**Revised
Corrective Action Plan
Proposed Aspire High School Site
1009 66th Avenue, Oakland, California
(Fuel Leak Case No. RO0000411)**

**July 17, 2009
003-09155-02**

Subject: Revised Corrective Action Plan, Proposed Aspire High School Site, 1009 66th Avenue, Oakland, California (Fuel Leak Case No. RO0000411)

Response to ACDEH Comments

Analytical Results for Groundwater Samples March 2009

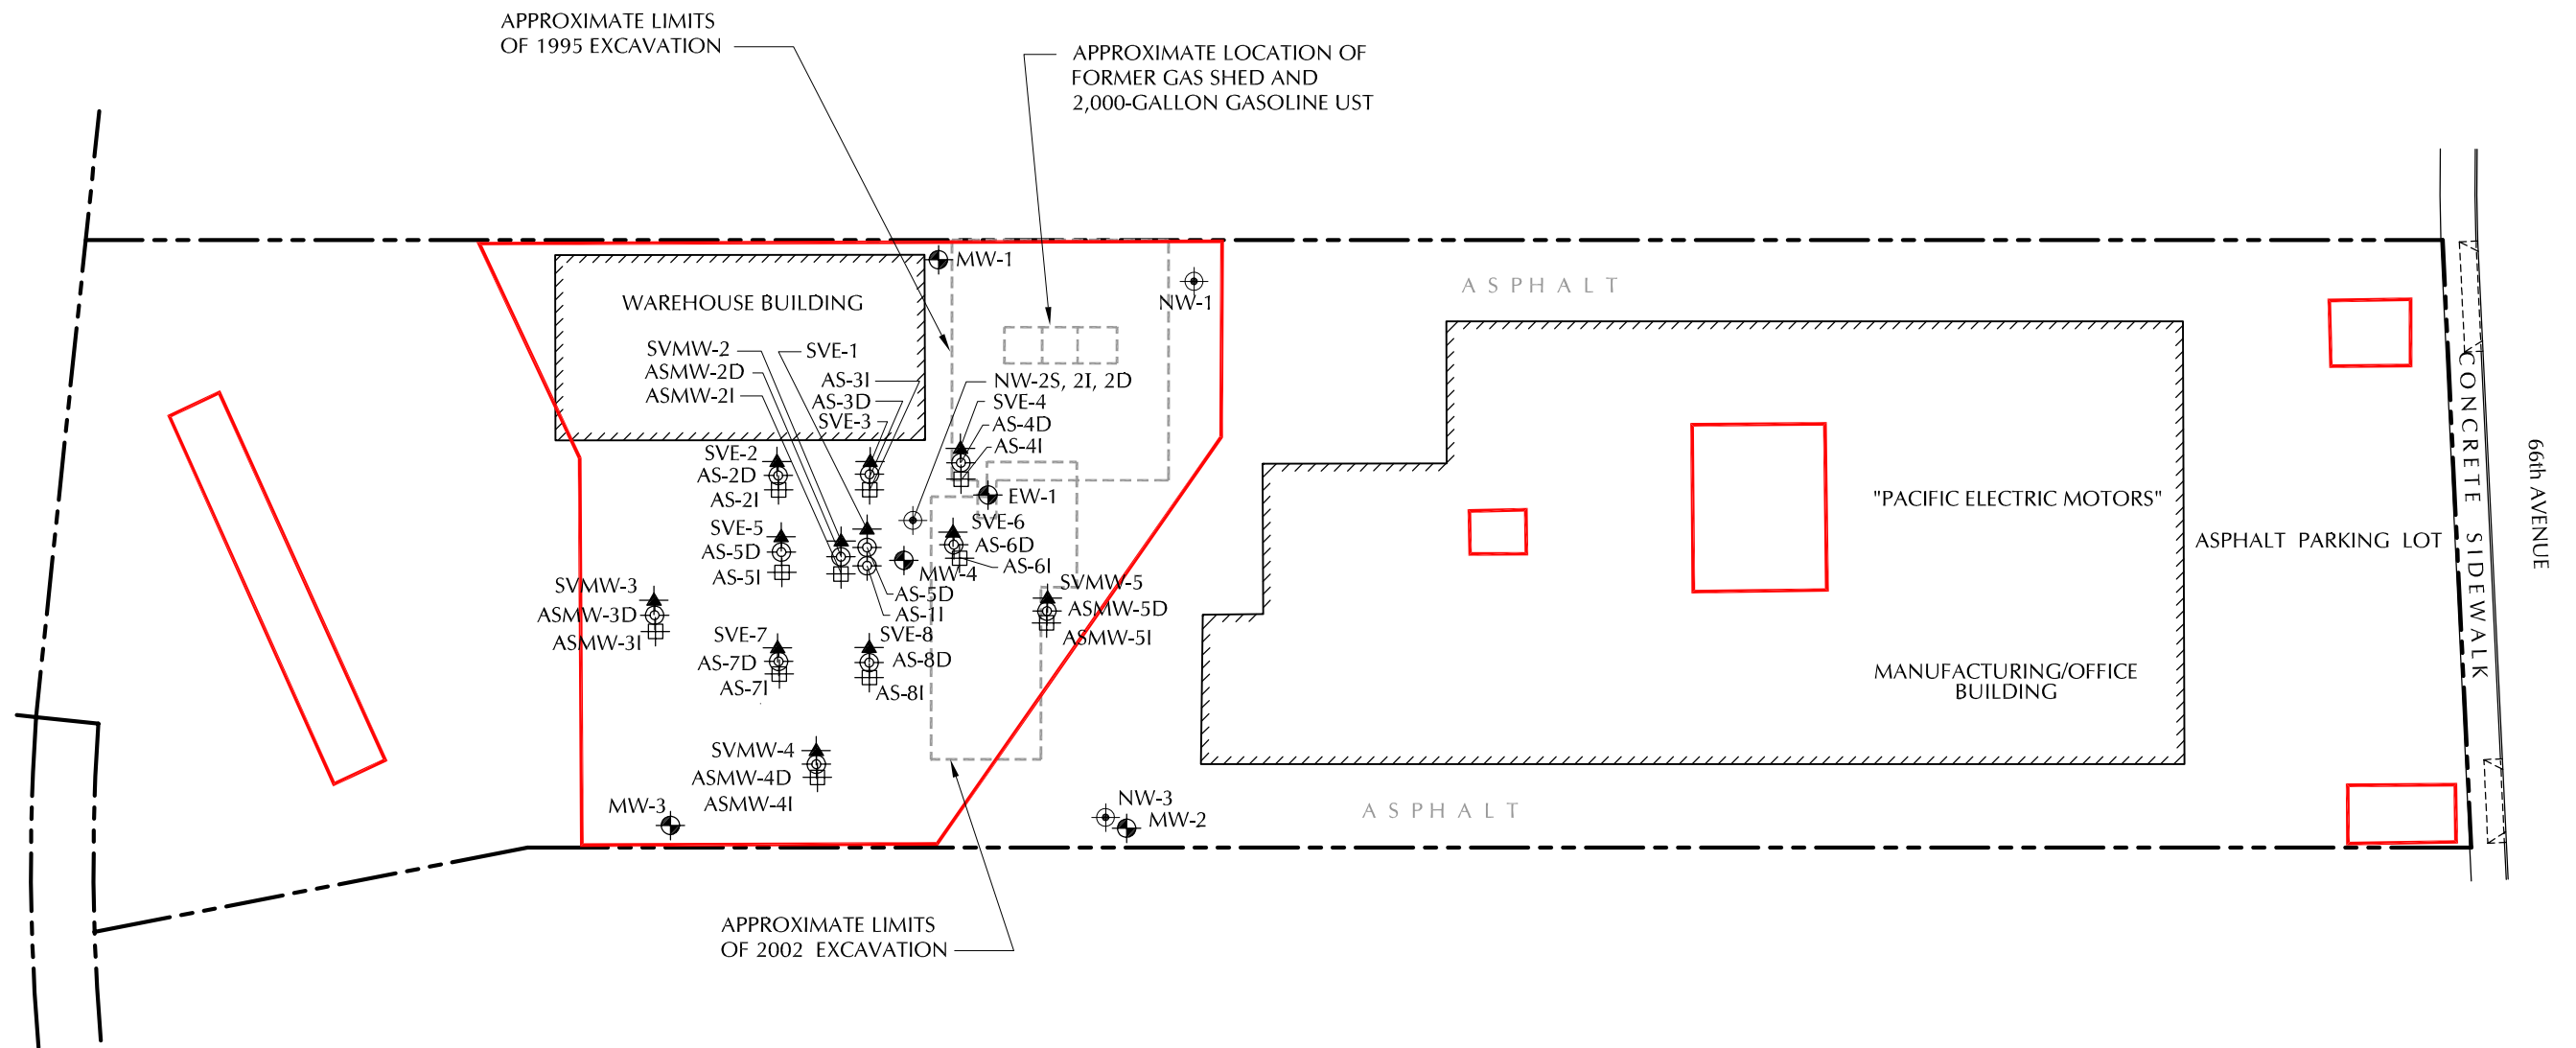
4. *Revised Site Figures* – Revised figures are included in the revised CAP. Specifically, a map illustrating the proposed area of excavation (Figure 10) has been included in the CAP. In addition, the analytical results for groundwater samples recently collected at the Site and the estimated radius of influence of the groundwater remediation system are provided as Figure 9.
